Accessibility Assessment Report

Proposed Multi Level Warehouse Facility
49 Stephen Rd. Banksmeadow, NSW 2019

Reference: 230396

+ Date	30.10.24
+ Revision	0
+ Status	Revised Concept Design Review
+ Author	Rick Beardwood
+ Reviewed	Michael Potts

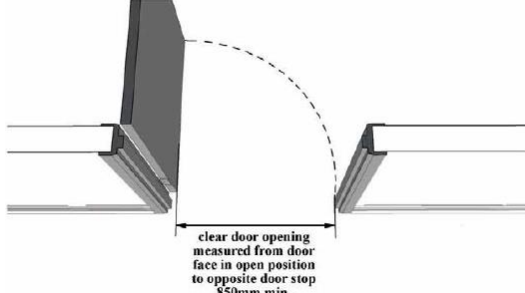
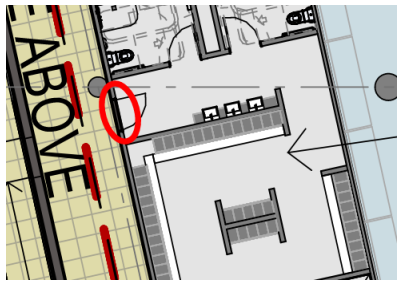
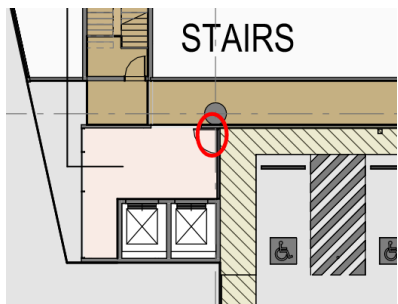
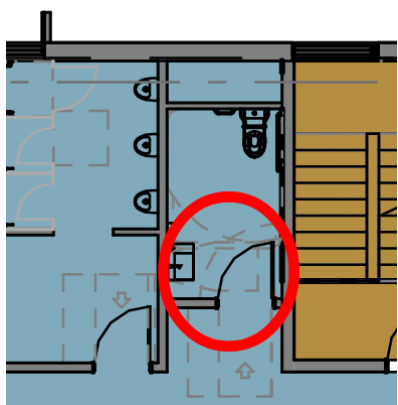
+ Clause	+ Reference	+ Comment
	detailed Design Development / Construction Issue Architectural Documentation.	
	<p>Set Down Areas</p> <p>Requirements for parallel parking</p> <p>If the set down area is level with the pavement, tactile indicators and bollards are required to be provided as required by AS 1428.4.1 – 2009.</p> <p>Requirements tactile / bollards</p>	
D4D4 Parts of buildings to be accessible	The works are required to comply with the requirements of AS 1428.1-2009.	<p>Compliance Readily Achievable:</p> <p>It appears there is a dedicated accessible pathway from the principal pedestrian entrance to the office areas as well as a pathway from the accessible car spaces to the offices.</p>
AS1428.1 Cl. 6.1 General	A continuous accessible path of travel shall not include a step, stairway, turnstile, revolving door, escalator, moving walk or other impediment.	<p>Further Information Required:</p> <p>Throughout the accessible pathway from the accessible car spaces on Ground Floor Mezzanine, there are instances where the width of the pathway is less than 1m wide due to the bollard layout. The pathway is to be widened. See the pathway below highlighted in yellow to be widened.</p>

AS1428.1 Cl. 6.2 Height of paths	The minimum unobstructed height of a continuous accessible path of travel shall be 2000 mm or 1980 mm at doorways	Compliance Readily Achievable: Reflected ceiling plans nominating ceiling heights and door schedules nominating door dimensions are required.
AS1428.1 Cl. 6.3 Widths of paths	Unless otherwise specified (such as at doors, curved ramps and similar), the minimum unobstructed width of a continuous accessible path of travel shall be 1000 mm and the following shall not intrude into the minimum unobstructed width of a continuous accessible path of travel: <ul style="list-style-type: none"> + Fixtures and fittings such as lights, awnings, windows that, when open, intrude into the circulation space, telephones, skirtings and similar objects. + Essential fixtures and fittings such as fire hose reels, fire extinguishers and switchboards. + Door handles less than 900 mm above the finished floor level. 	Further Information Required: Throughout the accessible pathway from the accessible car spaces on Ground Floor Mezzanine, there are instances where the width of the pathway is less than 1m wide due to the bollard layout. The pathway is to be widened. See the pathway below highlighted in yellow to be widened.

AS1428.1 Cl. 6.4 Passing Space	Accessways must have passing spaces complying with AS 1428.1 at maximum 20m intervals on those parts of an accessway where a direct line of sign is not available.  <p style="text-align: center;">DIMENSIONS IN MILLIMETRES</p>	Further Information Required: There is no provision for passing spaces throughout the accessible pathway on the Ground Floor Mezzanine accessible pathway. There is to be provision every 20m for a passing space between wheelchairs.
